ARCHITECT'S SUPPLEMENTAL INSTRUCTIONS

PROJECT:	The Reserves at Magnolia New Apartment Complex Denton, TX	Report No.	One (1)
OWNER:	Overland Property Group Dan Maximuk 234 N. Santa Fe Ave, Suite A Salina, KS 67401	Date	Oct. 22, 2024
CONTRACTOR:	Snyder Construction Group 4820 N. Town Centre Dr. Ozark, MO 65721	Architect's Proj No.	21-3205
		Contract For:	General Construction Mechanical, Electrical

Please Note: Drawings and Specification Edits associated with this ASI are dated as **7-17-2024**. This date above is the date this ASI was issued.

THIRD FLOOR REFLECTED CEILING PLAN
3/32"=1'-0"

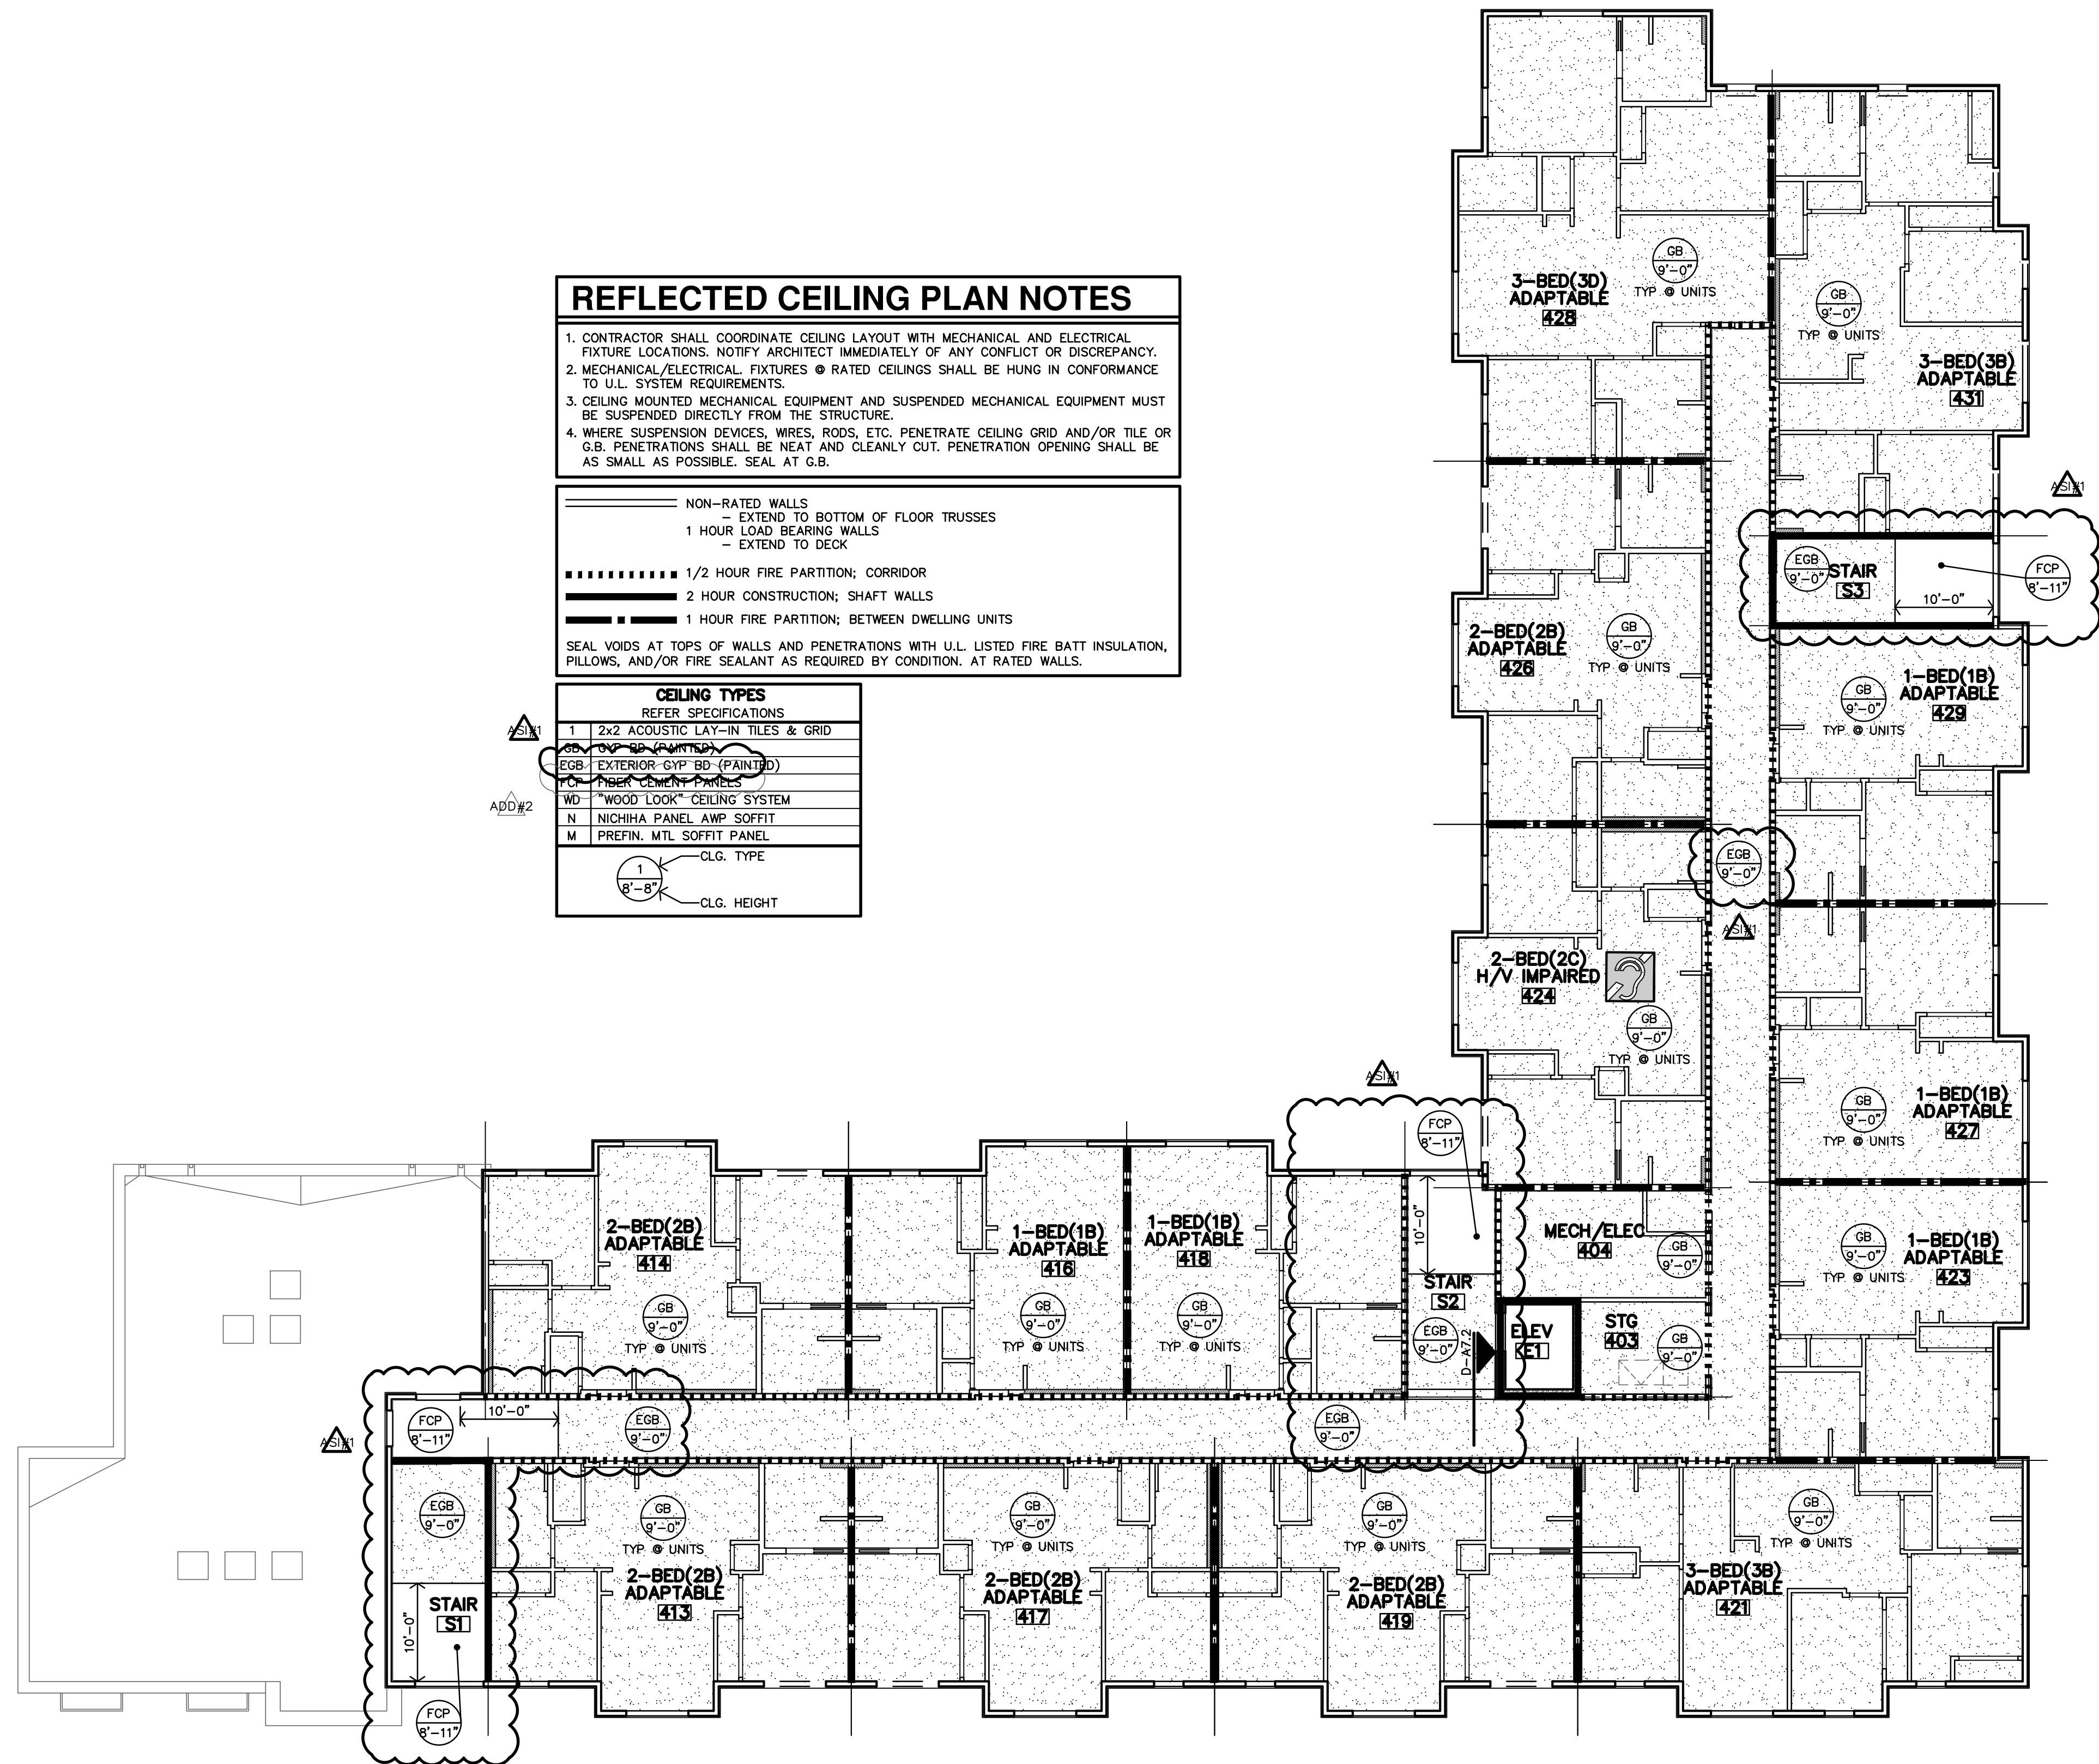
- 15) Utilize 5/8" type 'x' exterior-grade gypsum board finish at exterior breezeways in lieu of fiber cement siding and soffit. (VE Item #19) Exception: within 10 feet of each exterior opening. At these areas, fiber cement panel and trim shall be used. Reference revised details on Sheets A2.0, A3.3, A4.1, A4.6, A4.7, A4.8, A6.1, A6.2, A6.3, A7.1, A7.2, A7.3, and A7.4

A8.2

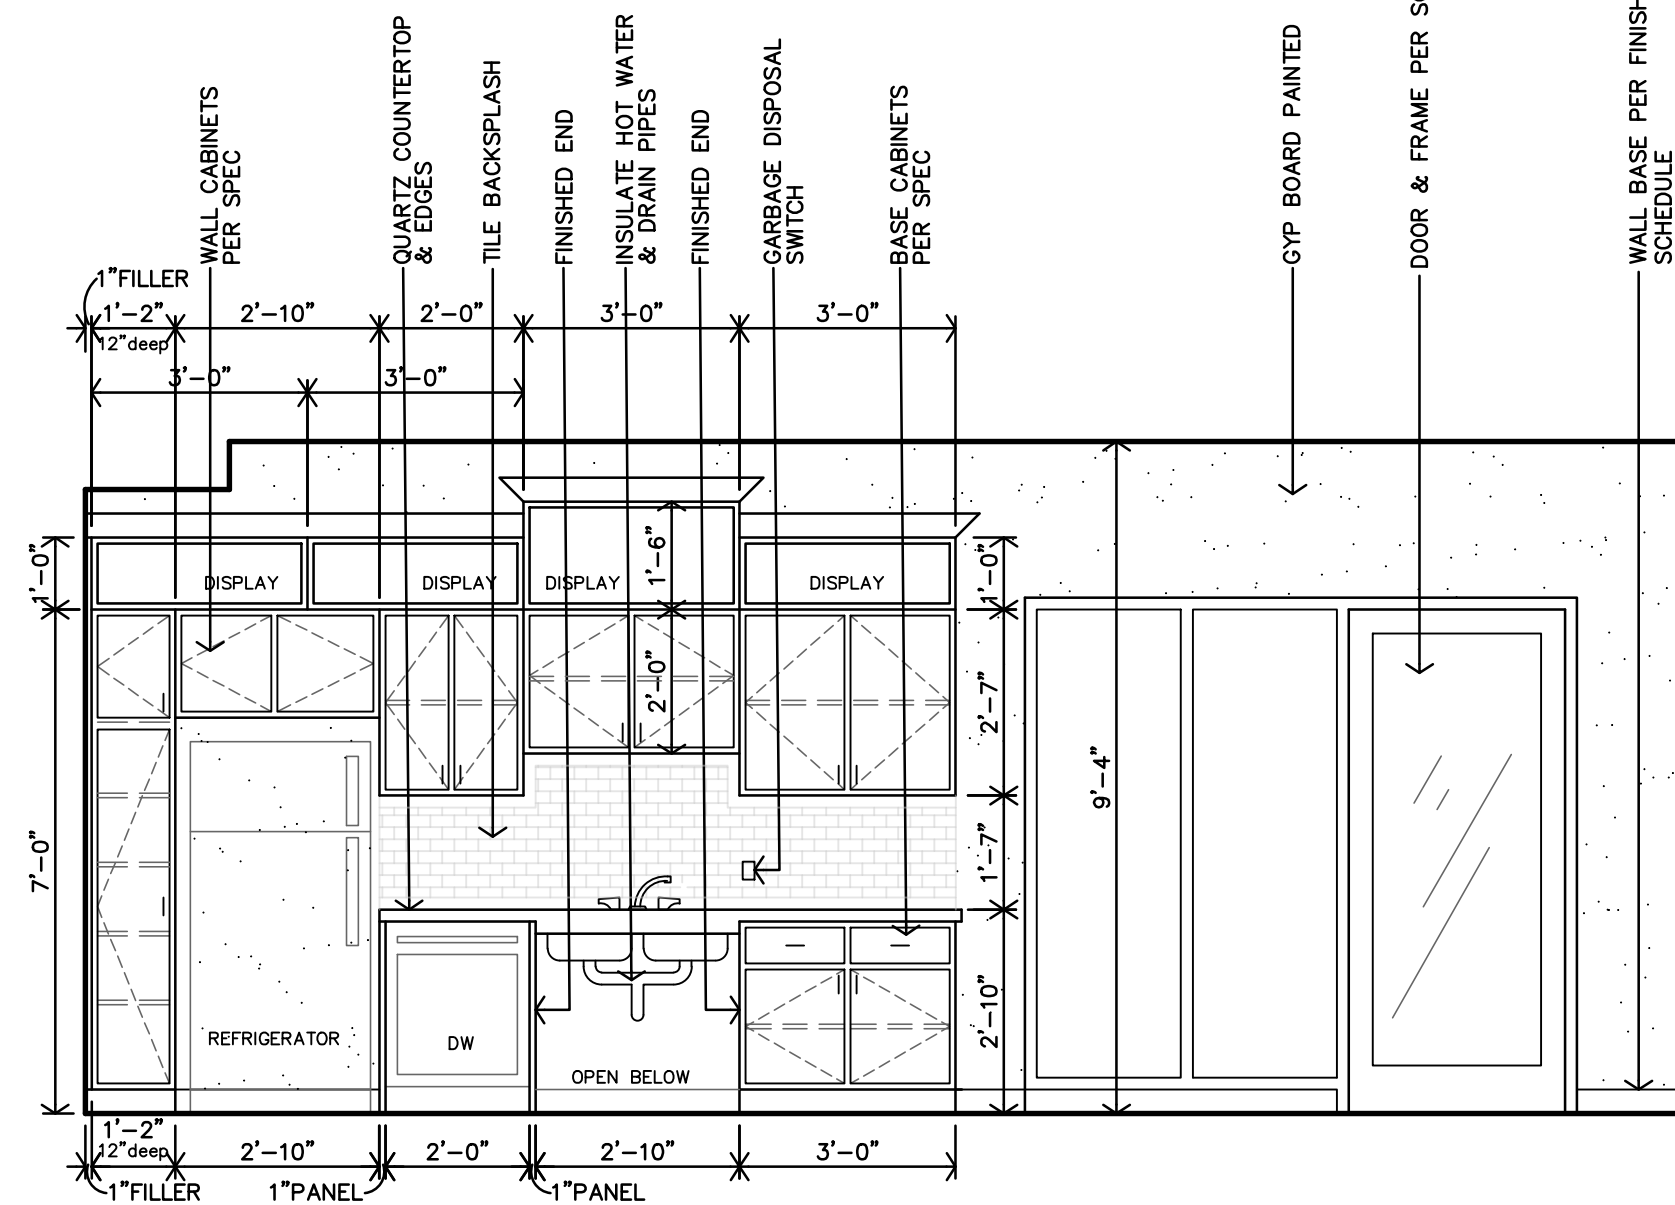
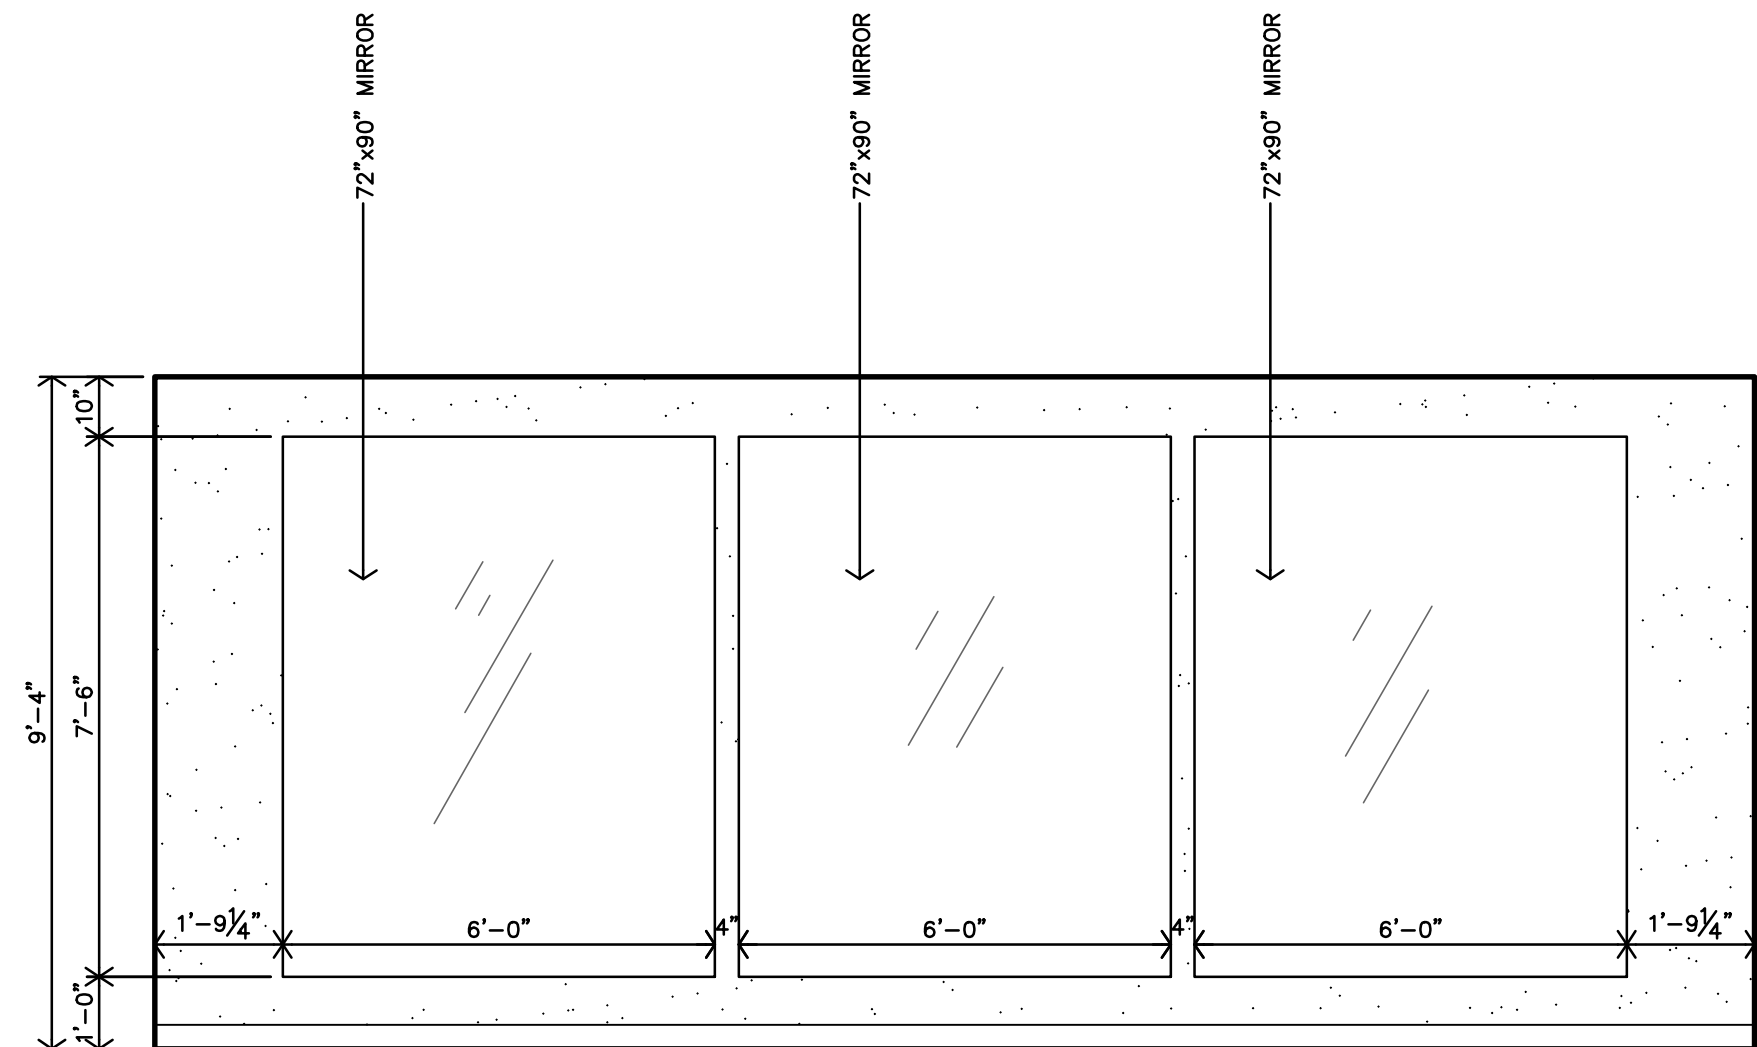
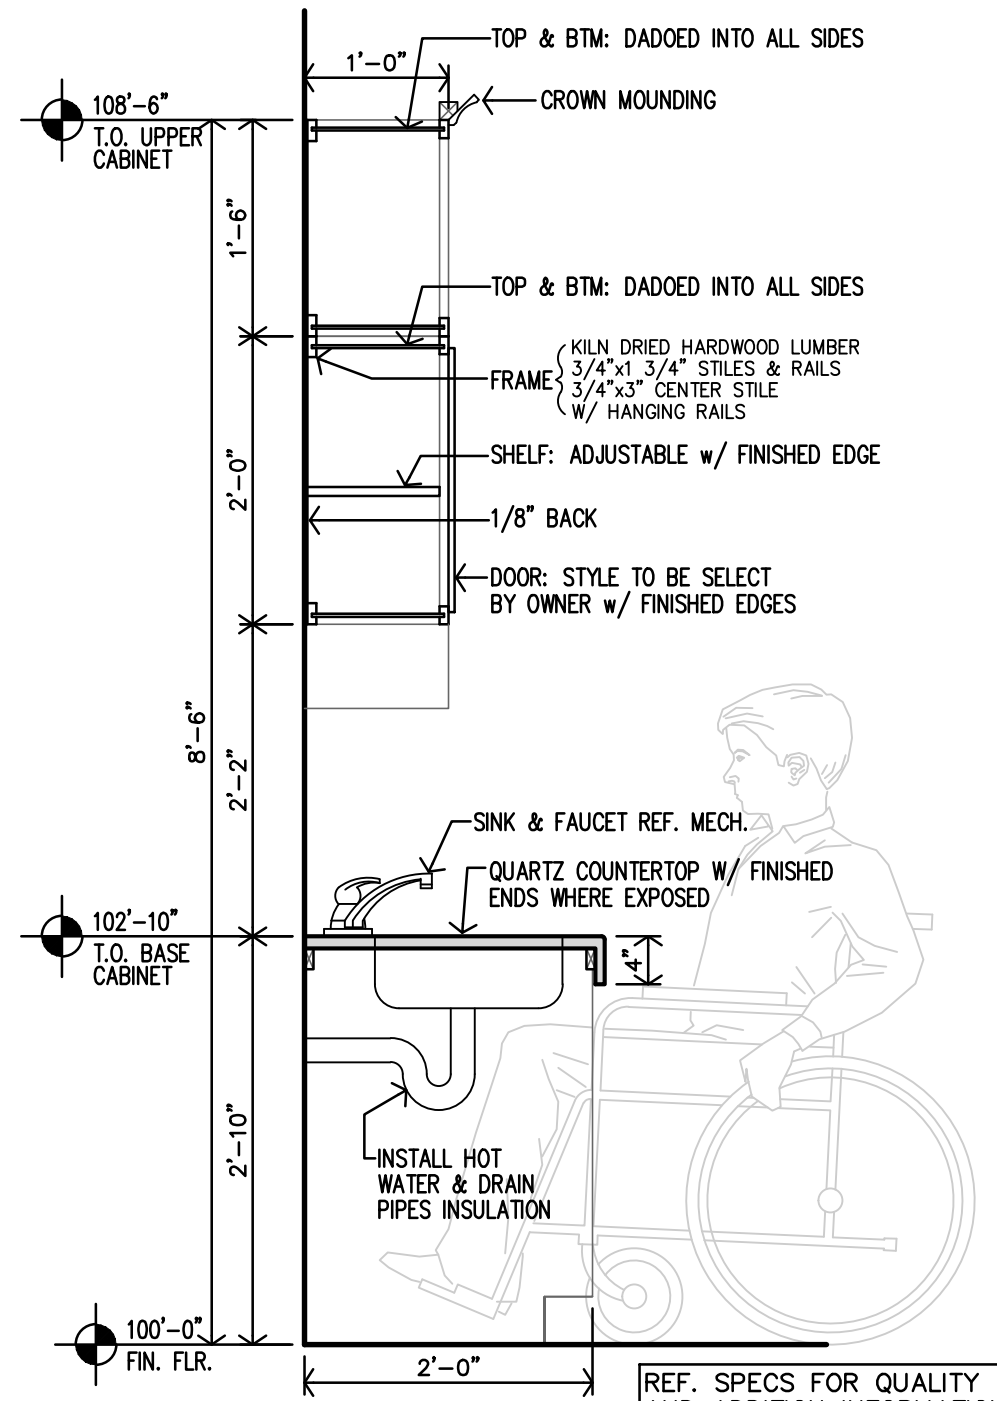
- 6) Omit all interior thin pre-cast panels at Community Room #106 - accent wall, and the entry vestibule area. (VE Item #9)
Reference Revised plans and details on Sheets A2.1, A4.2, A4.8 and A8.2.

- 40) Omit all individual unit water submeters from the project. (VE Item #47). Reference revised sheets P5.2 and P5.3
- 41) Omit the island casework in Community Room #106. (VE Item #48). Reference revised plans and details on A2.1 and A8.2.
